TOWN OF PLAINFIELD PLAN COMMISSION

DATE: 02-02-2026
Project Page: [Culver's – Gateway Drive](#)
CASE NO.: DP-25-099
PETITIONER: Brett Hickey, Kimley-Horn
REQUESTED ACTIONS: Architectural and Site Design Review for a proposed 4,550 (+/-) square foot Culver's restaurant with drive through on a 3.46-acre parcel zoned GC: General Commercial
LOCATION: Northwest corner of Hadley Road and Gateway Drive
PARCEL SIZE: 3.67 acres (+/-)

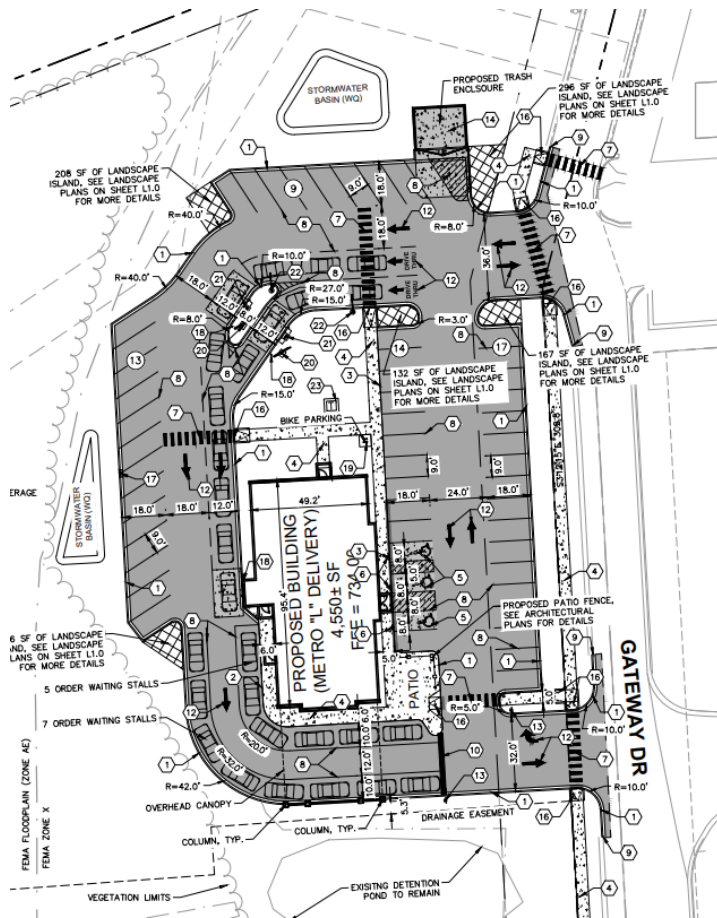
The site (shown on the left) includes a double-stacked drive through and multiple waiting areas for food, consistent with other Culver's designs and operations in the area. The site will be adequately served by pedestrian connections to Hadley Road as well as the MyPlace Hotel across Gateway Drive.

While the site includes parking between the building and the road (Gateway Drive), the double-frontage of the site and the applicant's inclusion of a drive-thru canopy (shown on the right) sufficiently mitigates the negative impact of parking being highly visible from the public right-of-way. Additionally, it is important to note that Gateway Drive north of Hadley Road is a private road. Considerations for the future roundabout at Hadley Road & Gateway Drive have been made.
